City of Portland, Maine – Building or Use Permit Application 389 Congress Street, 04101, Tel: (207) 874-8703, FAX: 874-8716

BUILDING PERMIT REPORT

REASON FOR PERMIT: To Construct a Single Family dwelling.

CITY OF PORTLAND, ME
BOCA 1996 Plan Review Record
One and Two Family Dwelling

BUY-THE-SEA PROPERTY
PARCEL OF LAND COMPRISED OF
SECTION 5 MAP 83A LOTS 4/5
CLEEVE STREET GREAT DIAMOND ISLAND
PORTLAND

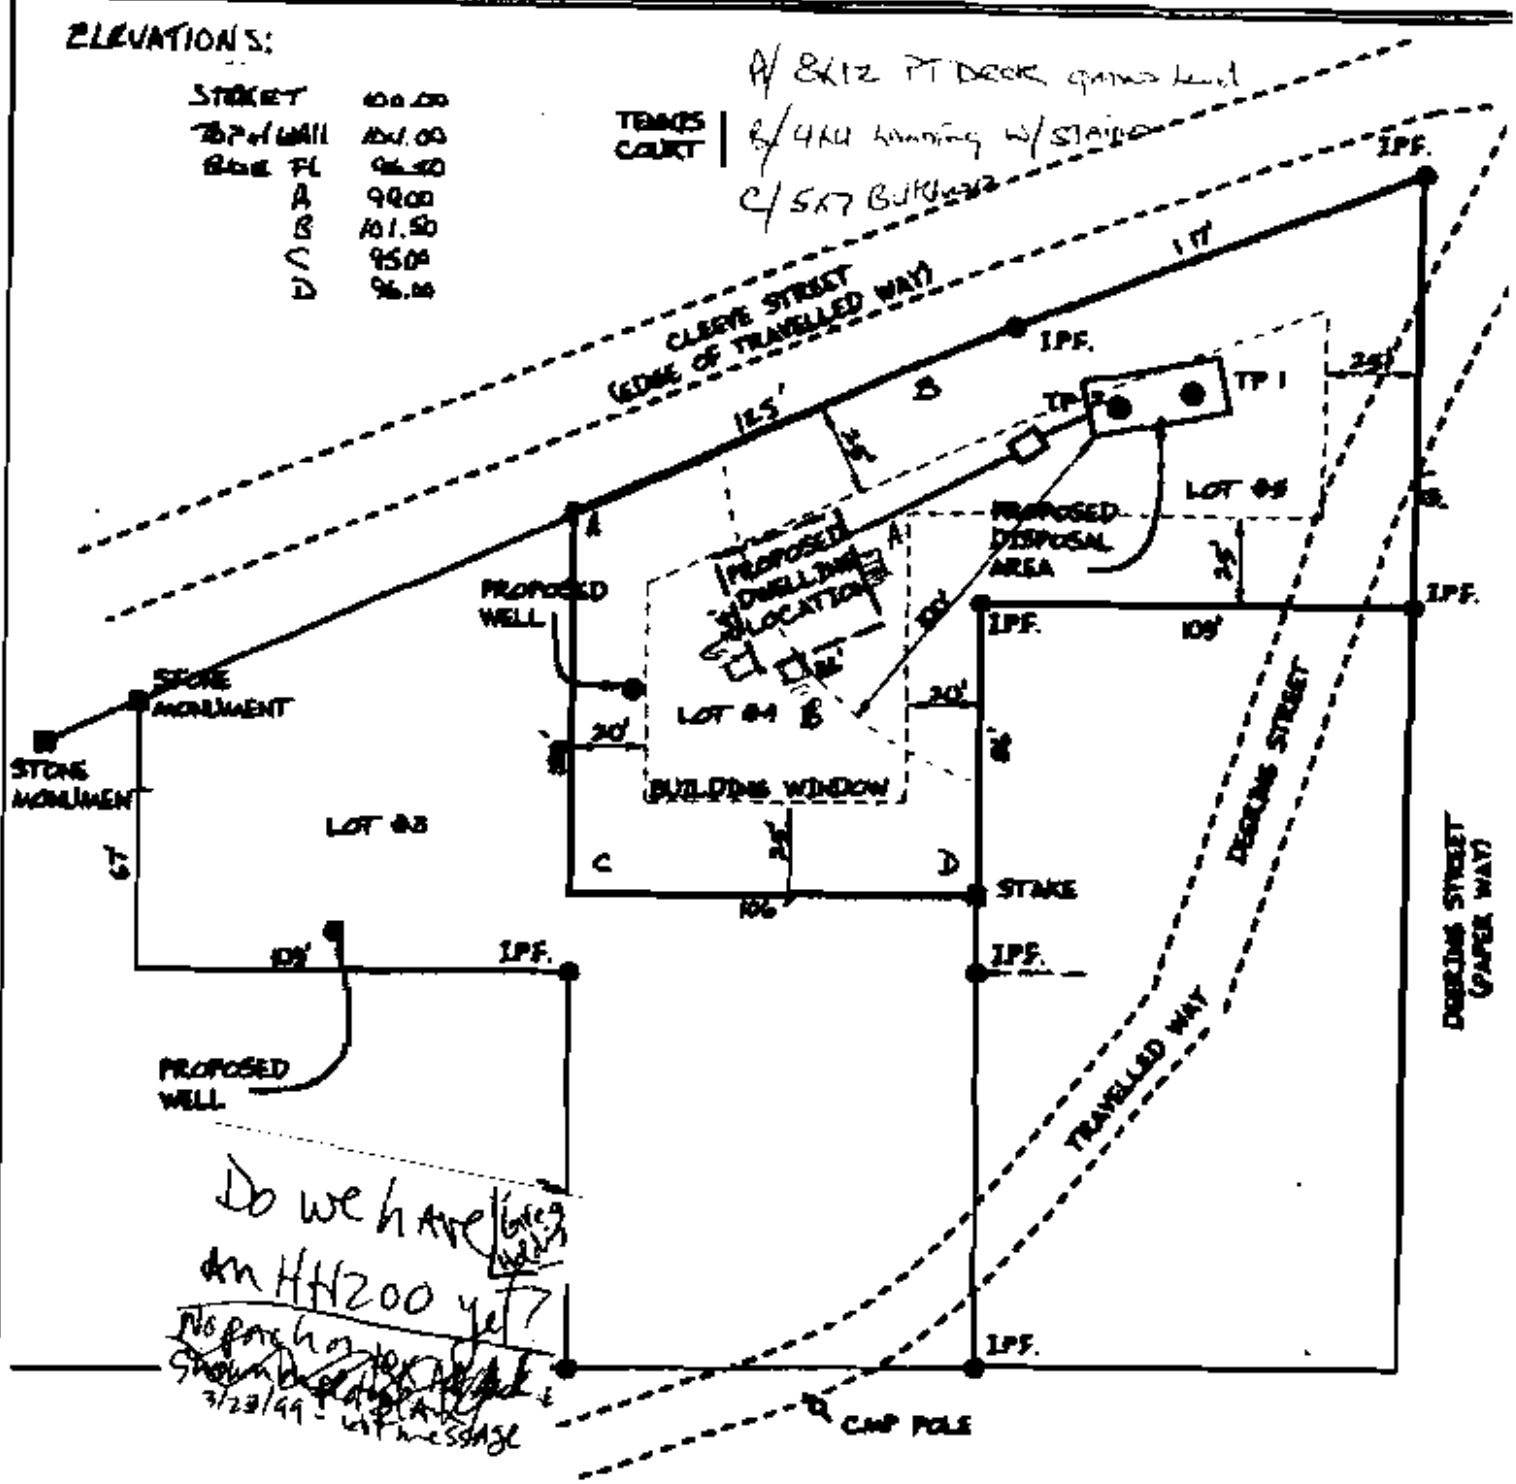
Do we have [illegible] an HH200 yet?
No [illegible] shown [illegible] 3/23/99 - left message

brought revised plan → Projections - Non shown on plot plan → 7/6/99 discovered revised plot plan with decks shown
